Detailed Site Plan
Departure from Design Standards
Alternative Compliance
Park Place

DSP-19044
DDS-665
AC-20005

STAFF REPORT

SUBJECT: Detailed Site Plan DSP-19044
Departure from Design Standards DDS-655
Alternative Compliance AC-20005
Type 2 Tree Conservation Plan TCP2-029-2019
Park Place

OVERALL SITE PLAN

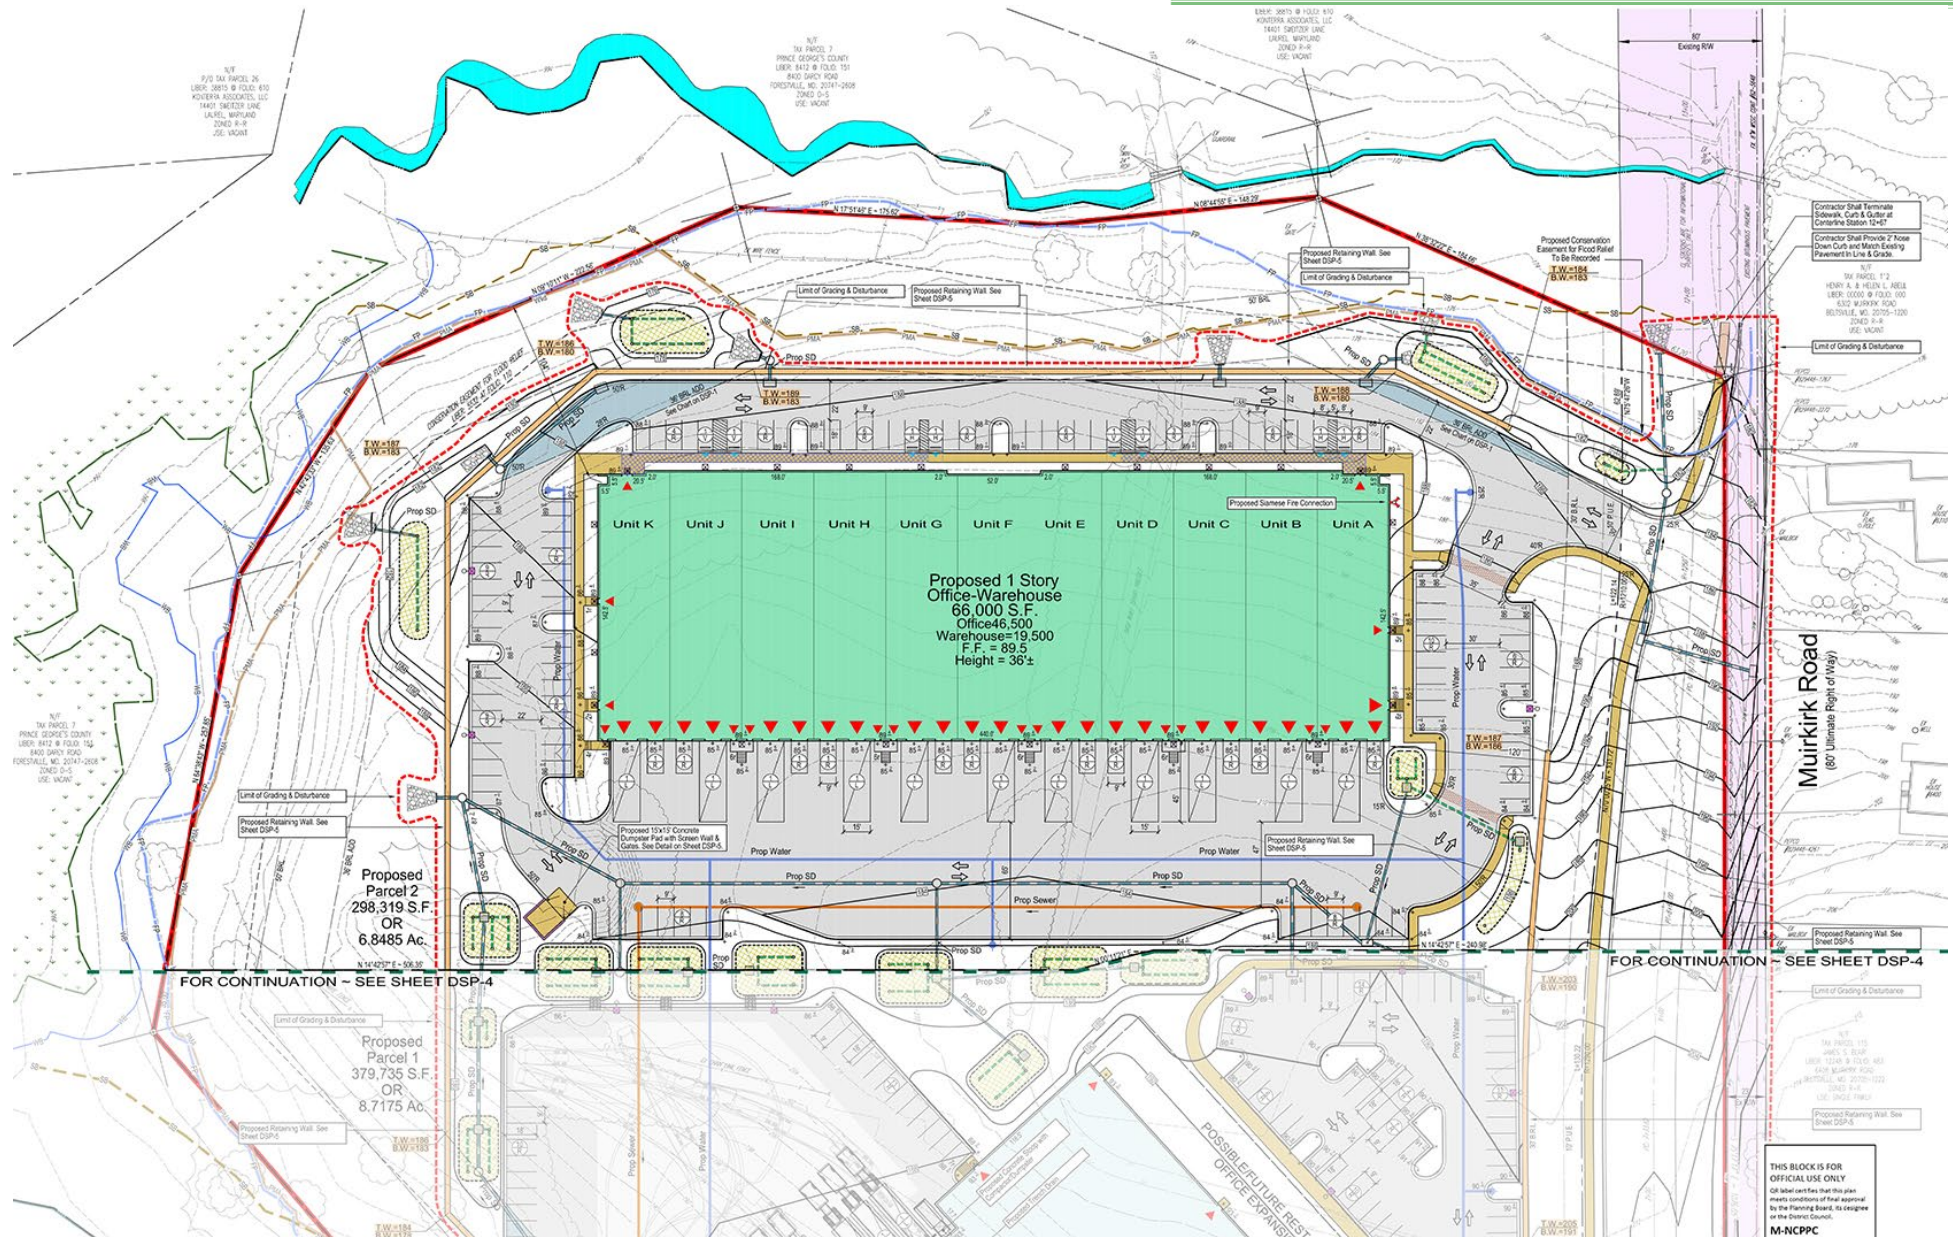
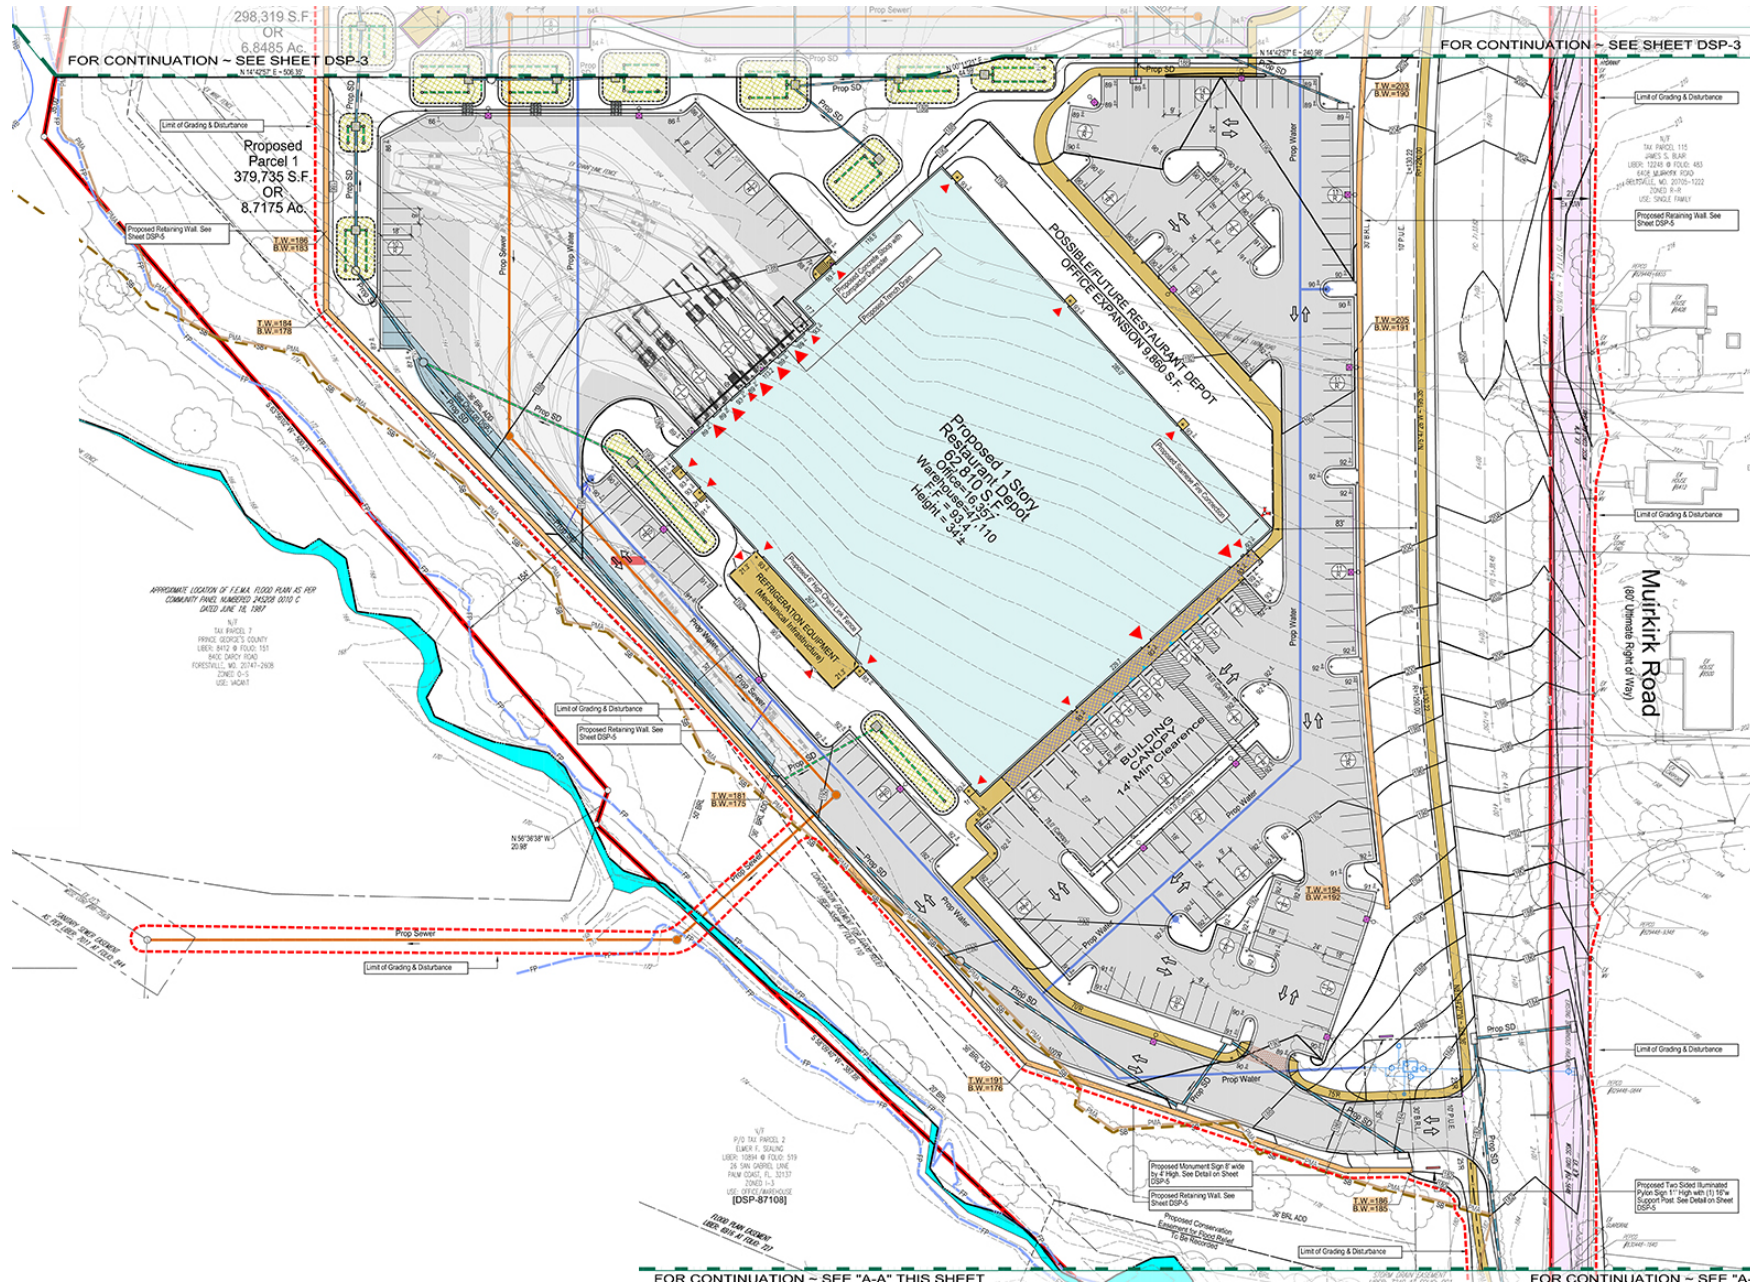
- f. Remove the building-mounted signs on the western and southern sides of the building on proposed Parcel 1.
 - g. Provide an inter-parcel vehicular driveway between proposed Parcels 1 and 2.

- j. Provide crosswalks across each of the site entrances from Muirkirk Drive.
 - k. Provide inverted-U style bicycle parking racks at locations convenient to the entrances of both buildings.

TYPE 2 TREE CONSERVATION PLAN

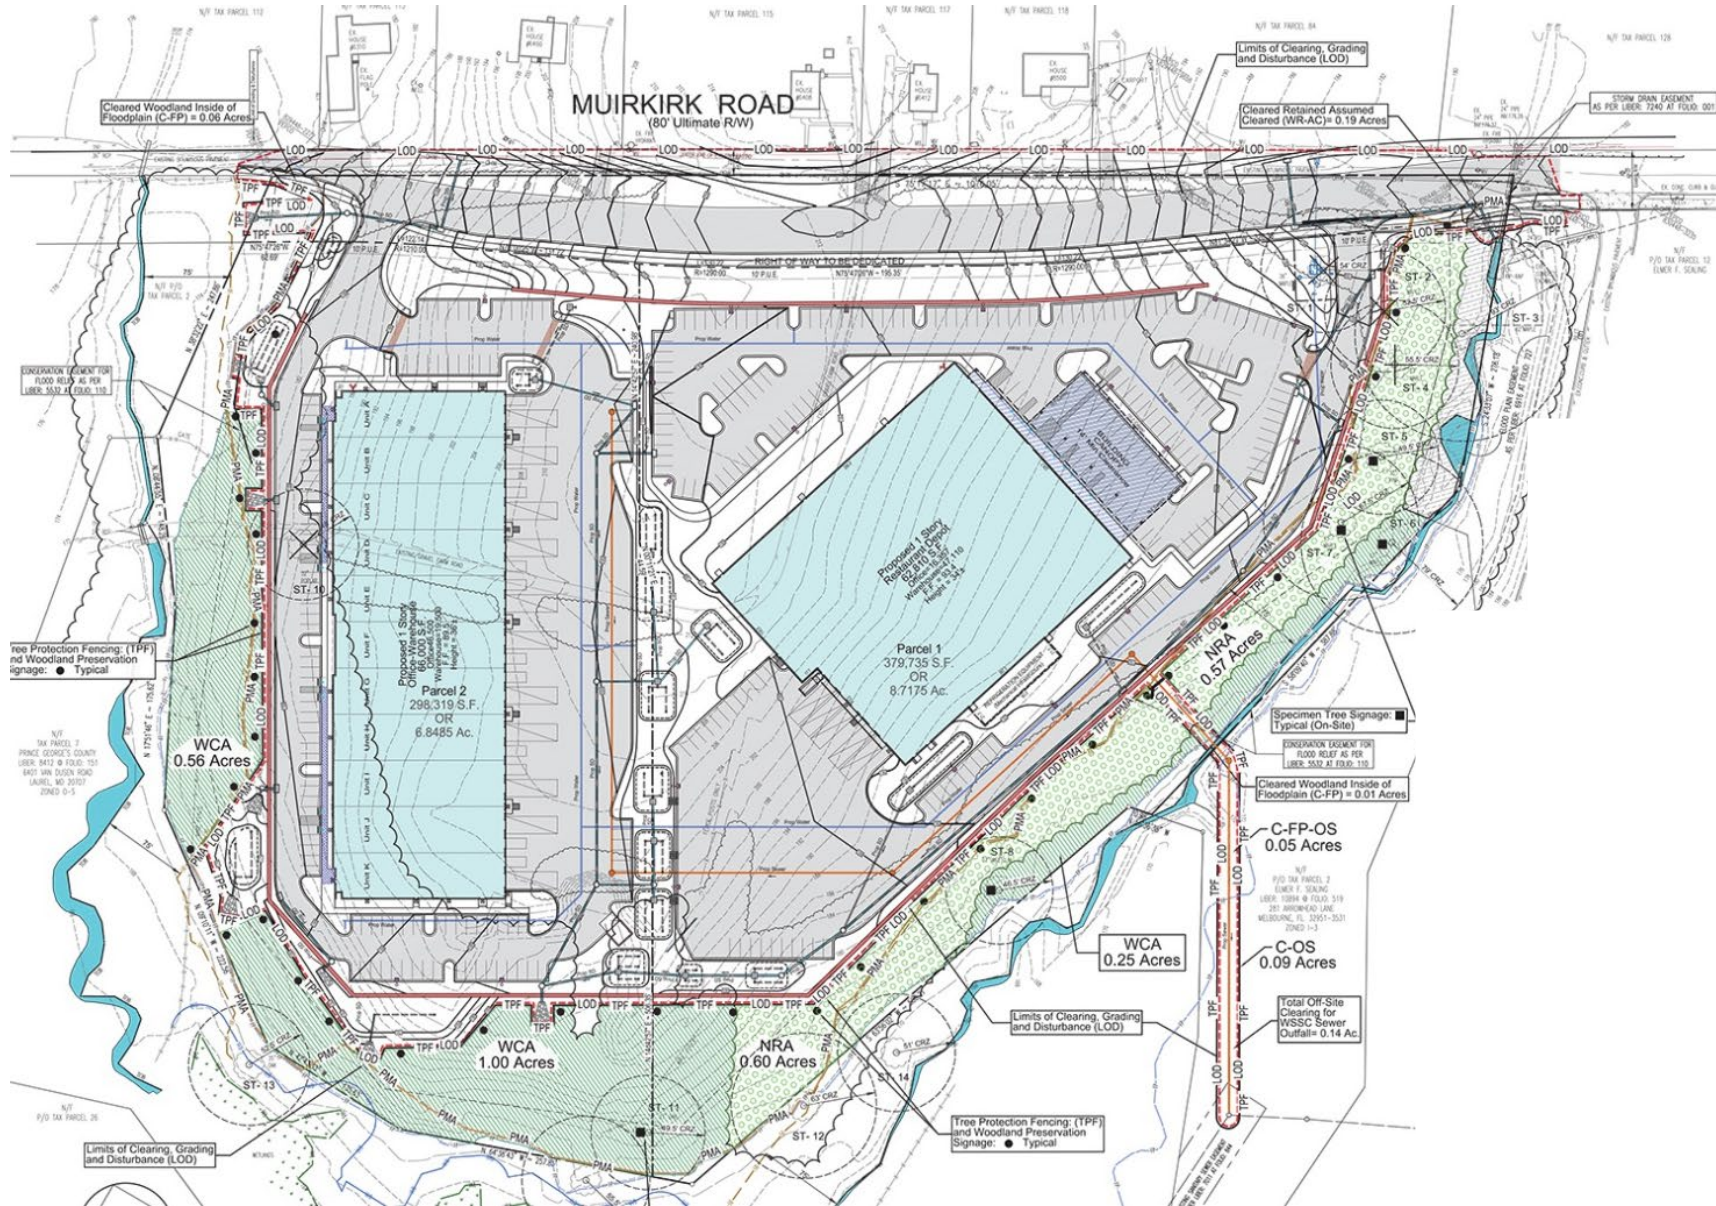
- a. Show woodlands as cleared within all proposed water and sewer easements.
 - b. Show all woodland conservation areas 10 feet from the top or bottom of all retaining walls.

- c. Update the Woodland Conservation Worksheet, as necessary.
 - d. Have all property owners or property owner representatives complete the Property Awareness Certificates on each sheet of the TCP2.

- e. Revise the location of all specimen tree signs in accordance with the Environmental Technical Manual.
 - f. Add the standard detail for Specimen Tree Signs per the Environmental Technical Manual to the plan.

- g. Complete General Note 1 with the required grading permit information.
 - h. Revise General Note 3 by replacing all references to “The Department of Public Works and Transportation or the Department of Environmental Resources” with “The Department of Permitting, Inspections and Enforcement (DPIE).”

RESTAURANT DEPOT ARCHITECTURAL ELEVATIONS

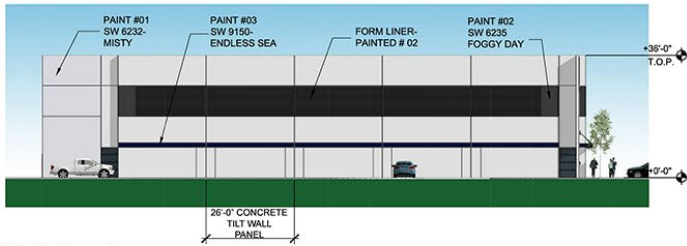
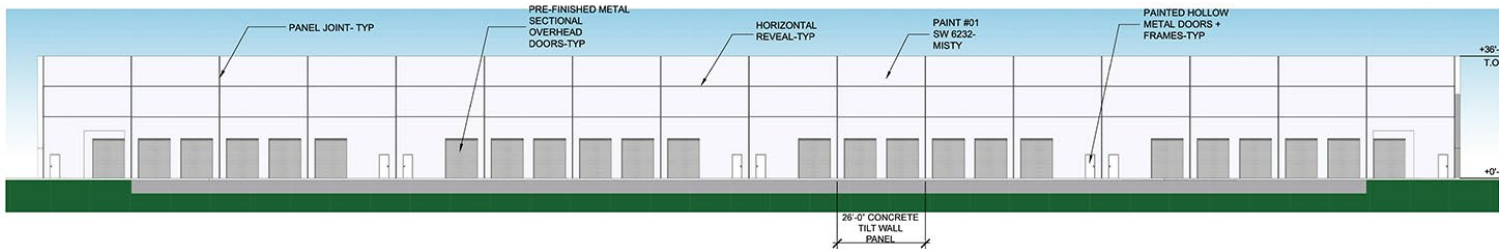
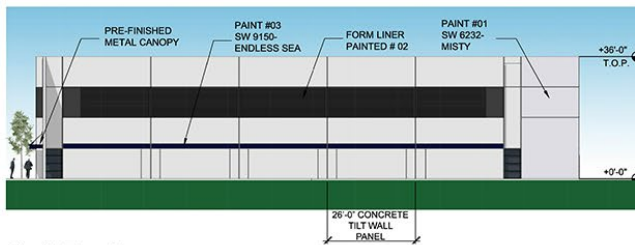
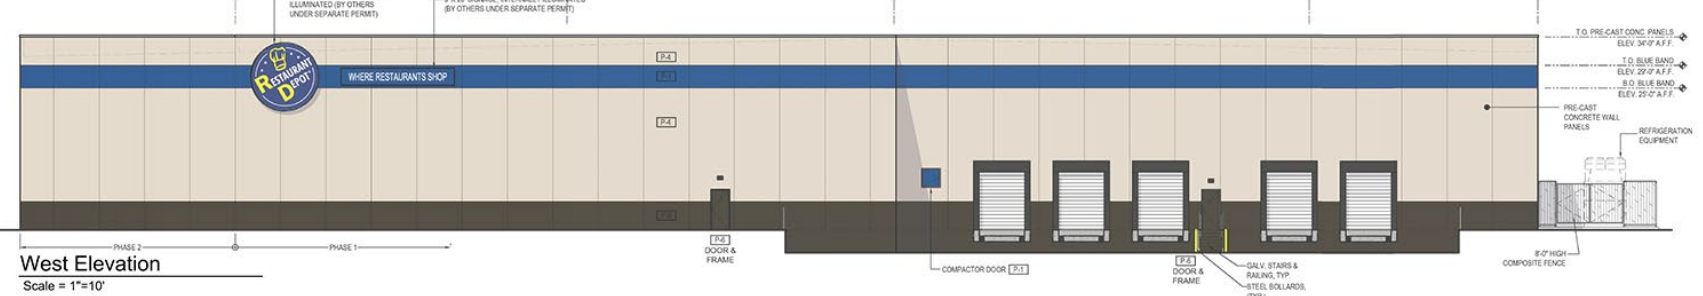
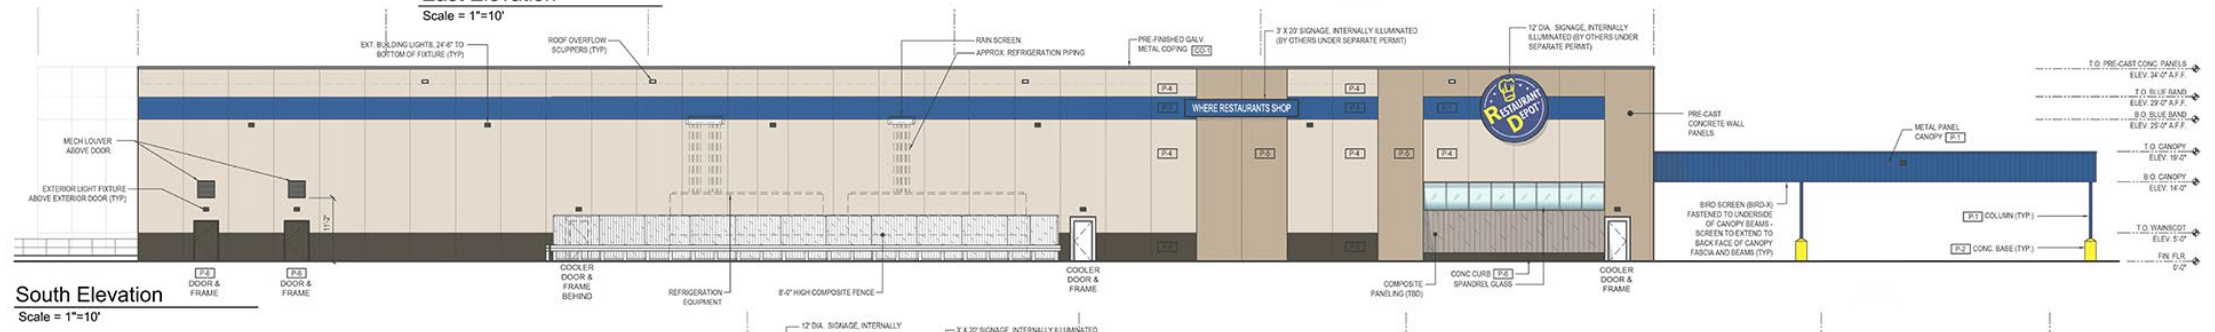
- b. Revise the eastern architectural elevation to include art and relay visual interest through incorporating fork, knife, and spoon columns used to support the entrance canopy.

- c. Add the horizontal dark gray band along the eastern elevation of the building on proposed Parcel 2.
 - d. Revise the general notes, architectural elevations, and site plan to reflect the accurate number of loading spaces and service doors for the building on proposed Parcel 2.
